# Access Compliance Report

## Public Rights-of-Way

### (Curb Ramps)

Intersection ID: 15397	Main Street: N_WENDOVER_RD	Cross Street: N_WENDOVER_RD_RA	Location: NE
ADA ID: 82D7DFFA3078	Ramp Type: Perp	Initial Pass/Fail: Fail	Overall Compliance: No
Severity Score: 21.25			
Codes/Mitigation Info/Possible Solution		Field Measurements/Component Compliance

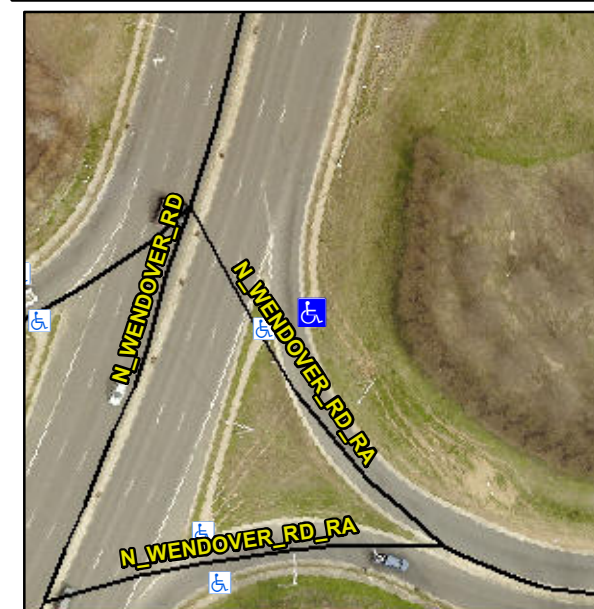
**Not Found, R304.5.1, R304.2.2**

Compliance	Description	Data	Compliance	Description	Data
N/A	Ramp Length (in)	84.0	No	Ramp Slope (%)	8.7
No	Ramp Width (in)	42.0	Yes	Ramp XSlope (%)	1.1
N/A	Flare Type LT	N/A	N/A	Flare Type RT	N/A
N/A	Flare Slope LT (%)	N/A	N/A	Flare Slope RT (%)	N/A
N/A	Flare Traversable LT?	N/A	N/A	Flare Traversable RT?	N/A
N/A	Landing Length (in)	N/A	N/A	DWS Provided?	N/A
N/A	Landing Width (in)	N/A	N/A	DWS Contrast?	N/A
N/A	Landing Slope (%)	N/A	N/A	DWS Length (in)	N/A
N/A	Landing X Slope (%)	N/A	N/A	DWS Full Width?	N/A
N/A	Landing Curb? (Y/N)	N/A	N/A	DWS Offset (in)	N/A
N/A	Shared Landing?	N/A			
N/A	Gutter Ponding?	N/A	N/A	Gutter Slope (%)	N/A
N/A	Gutter Lip Ht (in)	N/A	N/A	Gutter X Slope (%)	N/A
N/A	Painted X Walk1?	No	N/A	Painted X Walk2?	N/A
	X Walk 1 Direction	To SW		X Walk 2 Direction	N/A
N/A	X Walk 1 Width (in)	N/A	N/A	X Walk 2 Width (in)	N/A
	X Walk 1 Slope (%)	1.1		X Walk 2 Slope (%)	N/A
	X Walk 1 X Slope (%)	1.1		X Walk 2 X Slope (%)	N/A

N/A	Ramp inside XWalk1?	N/A	N/A	Ramp inside XWalk2?	N/A
	Road Slope (%)	N/A	N/A	Clear Space?	N/A
	Road X Slope (%)	N/A	N/A	Clear Space to XWalk (in)	N/A
N/A	Any Obstructions?	N/A	N/A	Storm Grate/Utility Hazard?	N/A
	Obstruction Type			Storm Grate/Utility Type	
		N/A			N/A
			Yes	Surface Condition? (G/P)	Good

**Remove & Replace Entire Ramp.**
